Position Statement from National Highways

Title:	National Highways Update – Deadline 5
Reference:	TR050007
Applicant:	Tritax Symmetry
Proposal:	Application by Tritax Symmetry (Hinckley) Limited for an Order Granting Development Consent for the Hinckley National Rail Freight Interchange
Author:	National Highways (20040073)
Date:	09 February 2024

Table D5.1: Summary of outstanding matters and progress

Point C Westbound

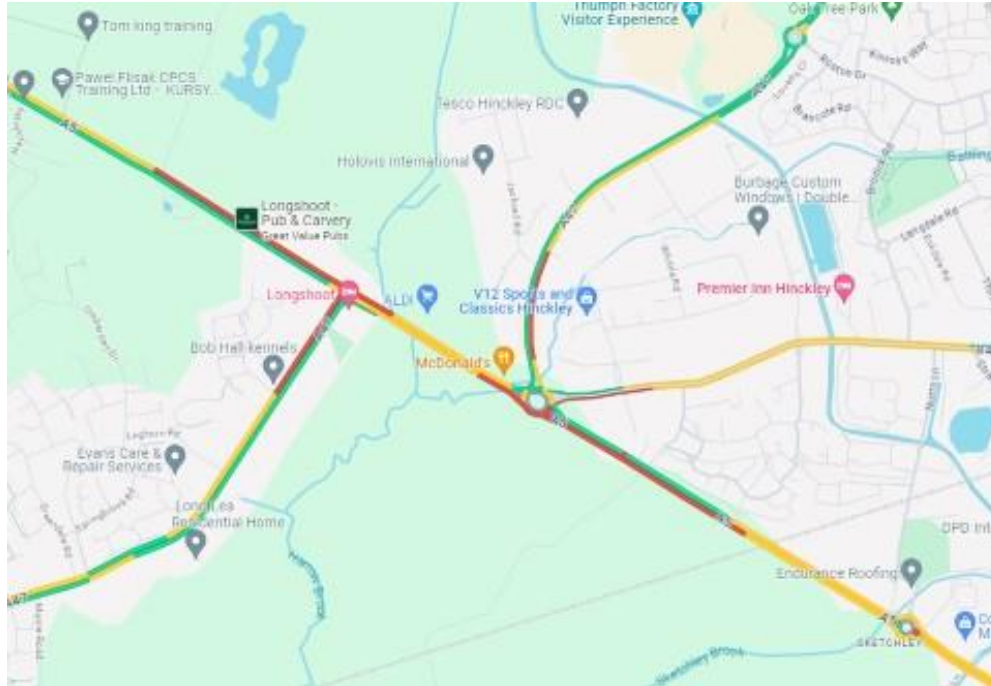
- The queue generated by the capacity constraints at the Longshoot extends up through the Dodwells Circulatory affecting the operation of the other arms.
- Westbound vehicles tend to block the roundabout as seen in the screenshot. This queue is caused by the lane reduction on the westbound exit and the queues from the Longshoot occasionally reaching back to the Dodwells Circulatory.

Point C Westbound

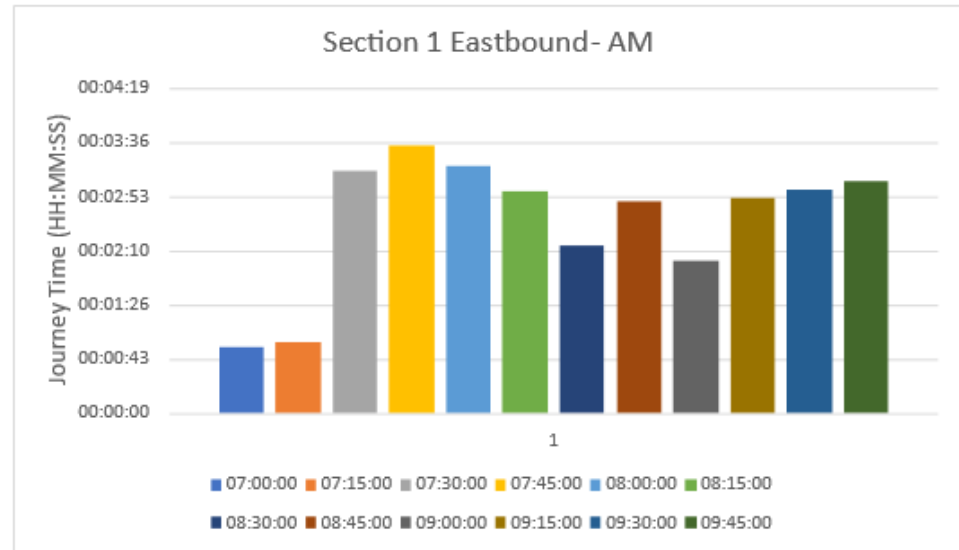
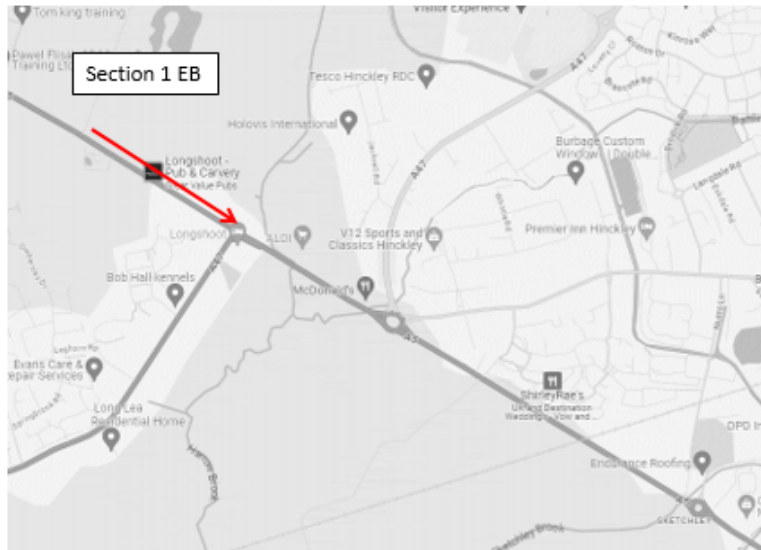
- The queue generated by the capacity constraints at the Longshoot extends up through the Dodwells Circulatory affecting the operation of the other arms.
- Westbound vehicles tend to block the roundabout as seen in the screenshot. This queue is caused by the lane reduction on the westbound exit and the queues from Longshoot occasionally reaching back to the roundabout.

**Annex C - A5 the Longshoot and Dodwells
Journey Time Analysis AM Peak**

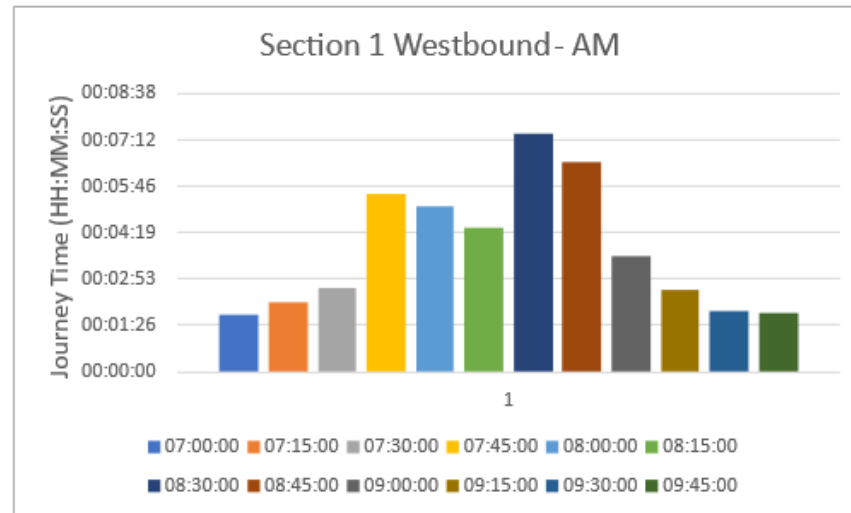
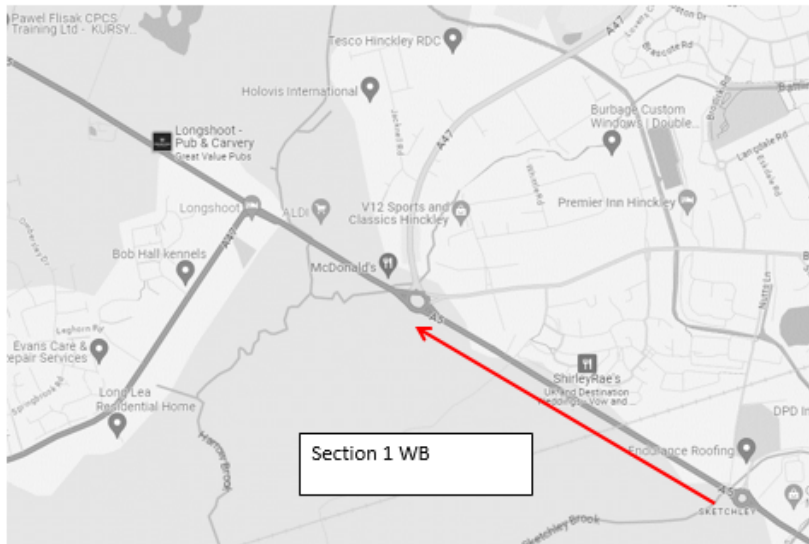
- The journey times analysed in the graph above have been collected by the ANPR cameras, and represent the average journey time across Section 1 every 15 minutes.
- Section 1 EB is approximately 450 m long.
- In the eastbound direction along the A5, queues start to develop around 07:30 as seen in the screenshots from the video footage.
- The journey time data shows a sudden spike in journey times around 7:30 (it should be noted that these journey times have been averaged every 15 minutes).
- The journey time data analysis shows that the journey times along this sections increase from 43 seconds before the peak hour to over 3 minutes during the peak hour, demonstrating that the junction generates **over two minutes of delay** between 7:30 and 10:00
- This is equivalent to an **average speed of 6 mph** along the 450 metres section.

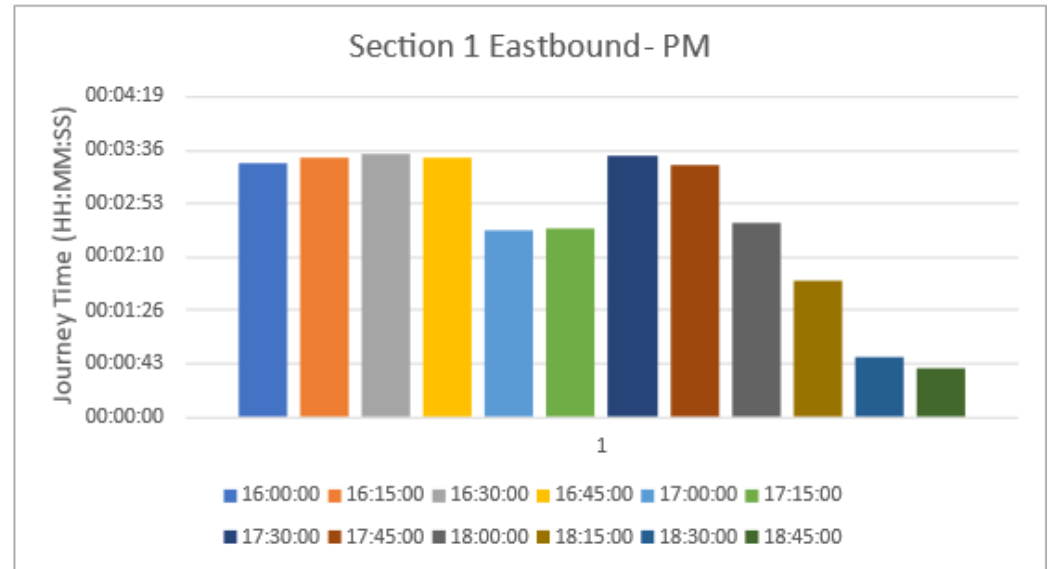
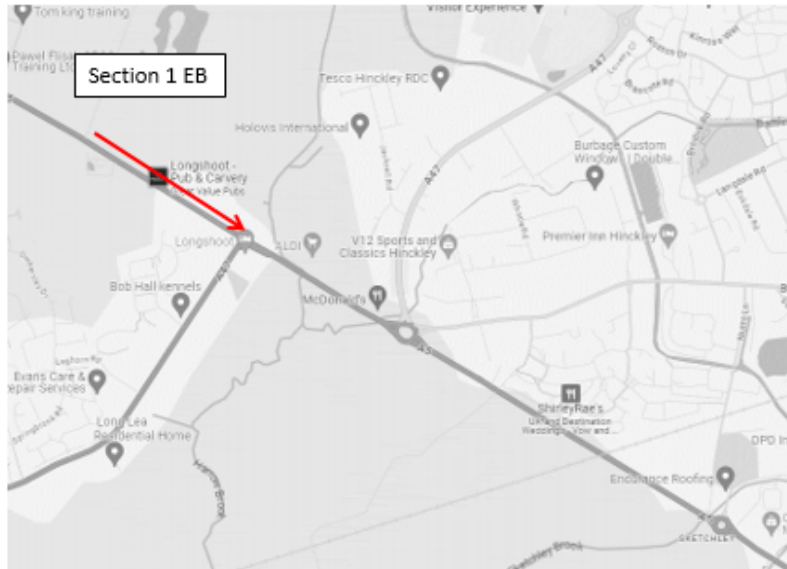
- The journey times analysed in the graph above have been collected by the ANPR cameras, and represent the average journey time across Section 1 every 15 minutes.
- Section 1 WB is approximately 1,100 m long.
- In the westbound direction along the A5, queues start to develop around 07:15 and dissipate after 09:15 as seen in the video screenshots
- This is also reflected in the journey times captured by ANPR with an increasing trend observed after 07:15 and a drop observed after 09:15
- During this time, the operation of Dodwells Circulatory generates **5 minutes of delay** along the A5, as the journey times increase from 1 minute and 30 seconds to over 5 minutes during most of the peak.
- This is equivalent to an **average speed between 7 and 8 mph** along the 1,100 metres section.
- The journey time reaches over 7 minutes during the worst part of the peak.

**Annex D - A5 the Longshoot and Dodwells
Journey Time Analysis PM Peak**

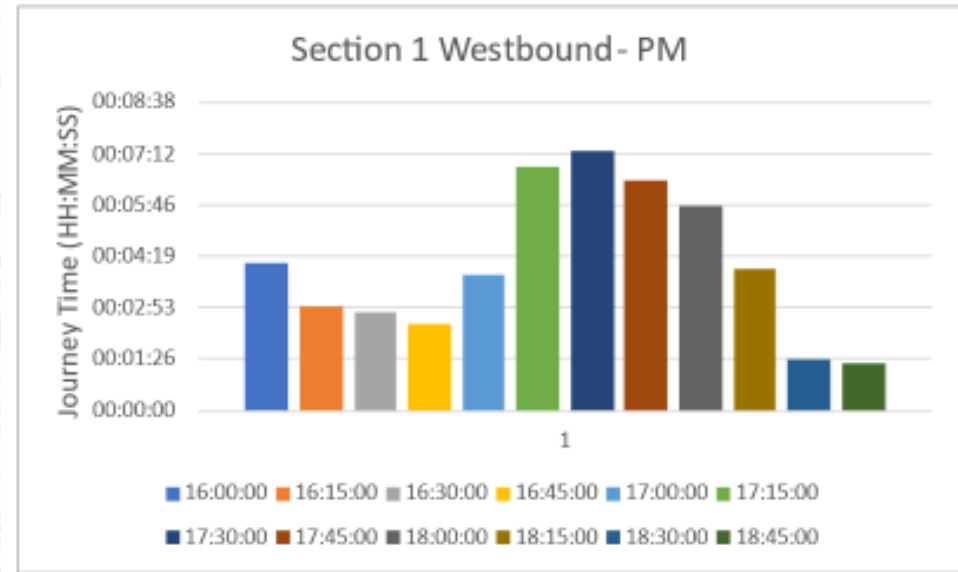
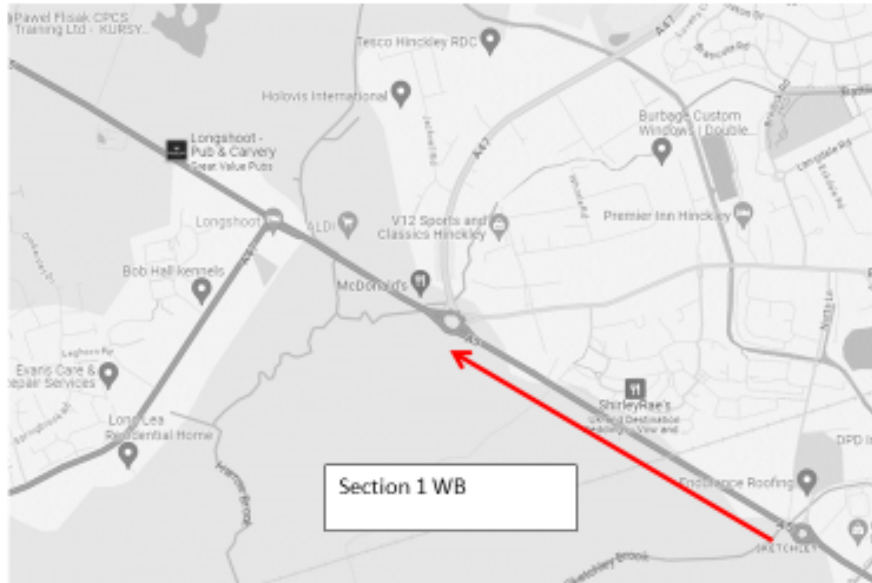
- The journey times analysed in the graph above have been collected by the ANPR cameras, and represent the average journey time across Section 1 every 15 minutes.

- Section 1 EB is approximately 450 m long.
- In the eastbound direction along the A5, queues have already reached the junction at 16:00 as seen in the screenshots from the video footage.

- The journey time data shows a consistent journey time of over 3 minutes, from 16:00 PM.
- The journey time data analysis shows that the journey times along this sections start to reduce at 18:15, dropping to the free flow conditions (43 seconds) by 18:30.

- During this period, 16:00 to 18:15 the junction generates over **two minutes of delay**. Which is equivalent to an **average speed of under 5 mph** along the 450 m section.

- It should be noted that the eastbound queue and the delays observed in the PM peak are smaller than in the AM peak.
